10/617,982

AMENDMENT IN RESPONSE TO OFFICE
ACTION MAILED NOVEMBER 1, 2005

Atty. Docket No. 200-65500
(PB030022AF)

FIG. 2

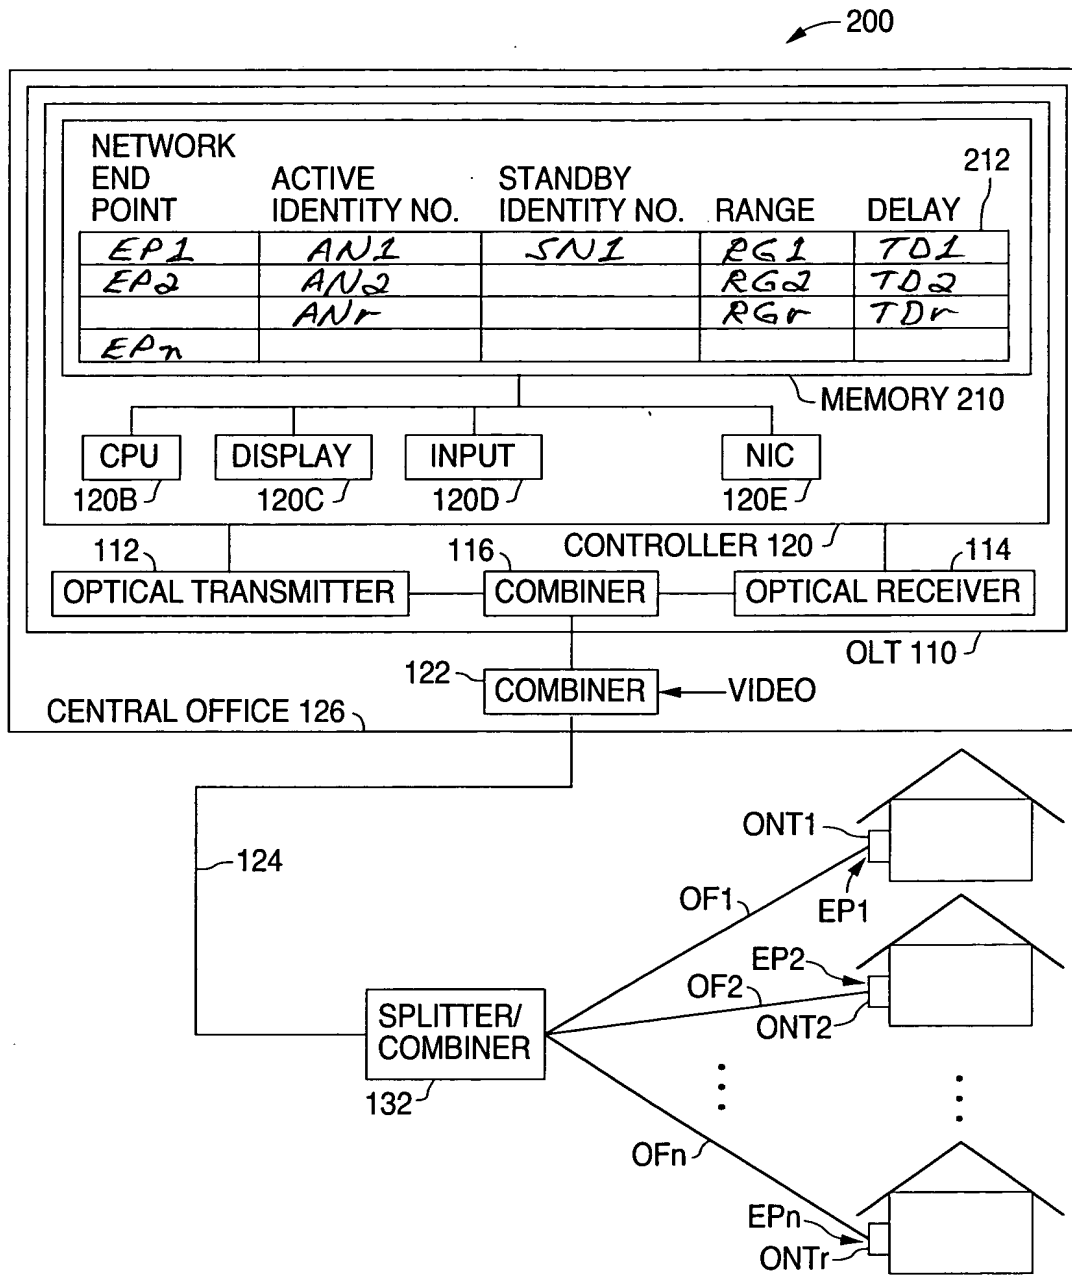
The Examiner objected to the drawings under 37 CFR §1.83(a) because the drawings do not show a memory that stores a first identification number that represents a first optical device that is associated with a network end point, and a second identification number that represents a second optical device that is associated with the network end point.

Applicant notes that applicant's FIG. 2 shows an example of a memory as a table 212 that has slots for storing a number of network end points, a number of active identity numbers which are associated with the network end points, and a number of standby identity numbers which are also associated with the network end points.

However, in order to further prosecution, applicant's specification has been amended to list reference numerals for the active identity numbers (AN1-ANr) of the optical network terminals ONT1-ONT_r used at the network end points, the ranges (RG1-RGr) to the optical network terminals ONT1-ONT_r, and the transmission delays (TD1-TDr) assigned to the optical network terminals ONT1-ONT_r.

In addition, FIG. 2 has been amended as shown in red to place the reference numerals for the network end points (EP1-EP_n), the active identity numbers (AN1-ANr), the ranges (RG1-RGr), and the transmission delays (TD1-TDr) in table 212. Amended FIG. 2 is attached in Appendix A, and a replacement sheet for FIG. 2 is attached in Appendix B. As a result, the drawings are believed to satisfy the requirements of 37 CFR §1.83(a).
